2.5TL SRS Unit Removal Changes

ACURA ServiceNews

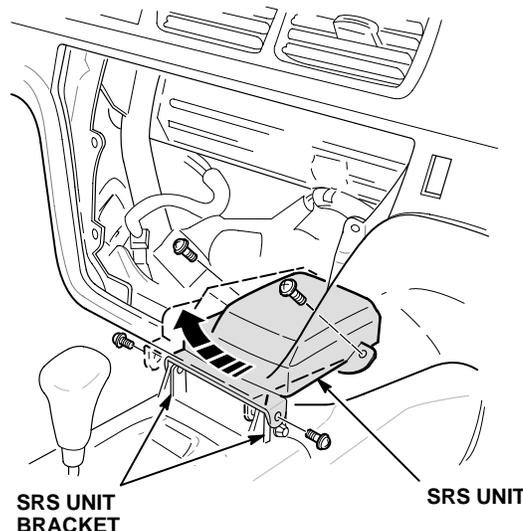
Due to a mid-production change in dashboard brackets, the SRS unit on a '96 2.5TL can't be removed as easily as the S/M describes. At first glance, it now looks like the dashboard must be removed, but it's not that bad.

First, follow steps 1 through 7 of the SRS unit replacement procedure on page 24-52 of the '95-96 2.5TL S/M. Then, follow these revised steps 8 and 9.

- Remove the four Torx bolts from the SRS unit, then shift the unit's rear mounting tabs up and over the SRS unit bracket, toward the left.

- Lift the front of the SRS unit, and push the rear of the SRS unit forward until the unit is upside down, then pull the unit out of the dashboard. Install the new SRS unit in the reverse manner.

Follow steps 10 through 17 on page 24-53 of the S/M to complete the replacement procedure.
